PRODUCT CHANGE NOTICE

PCN-2635 REV1

| Notification Date: | Implementation Date: | Product Family: | Change Type: | PCN #: |
|--|---|-----------------|--------------------------------------|--------|
| Qualification of Additional Clip Bonding, Lead Frame Structure (Matrix) and Mold Compound for Select Discrete Products | | | | |

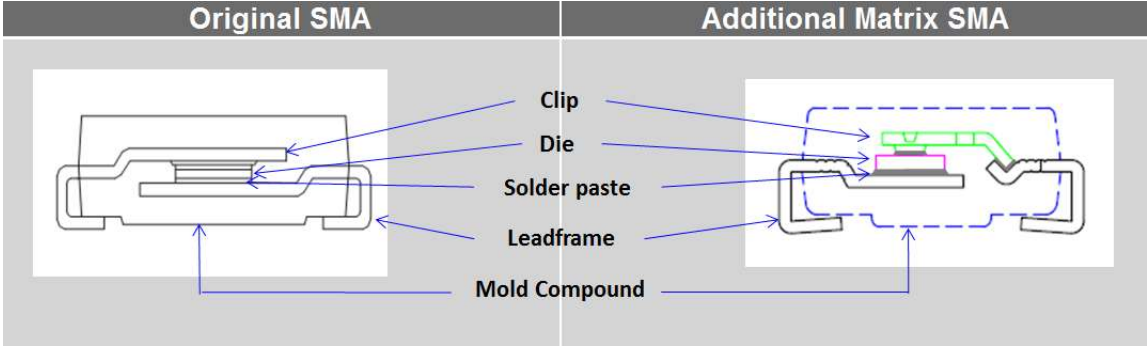
| Notification Date: | Implementation Date: | Product Family: | Change Type: | PCN #: |
|--|---|-----------------|--------------------------------------|--------|
| <p>This PCN is being issued to notify customers that in order to assure continuity of supply and to improve assembly manufacturability, Diodes Incorporated has qualified additional clip bonding, lead frame structure (Matrix) and mold compound at Diodes subcontractor Eris Technology Corp. (ERIS) in Taiwan for select Discrete products.</p> <p>Full electrical characterization and high reliability testing has been completed on representative part numbers to ensure no change to device functionality or electrical specifications in the datasheet. Refer to the attached qualification report embedded in this file (to view, download this PCN file then open it with a PDF viewer to see the attached qual report).</p> <p>Figure 1: Comparison of Package Construction</p>  | | | | |
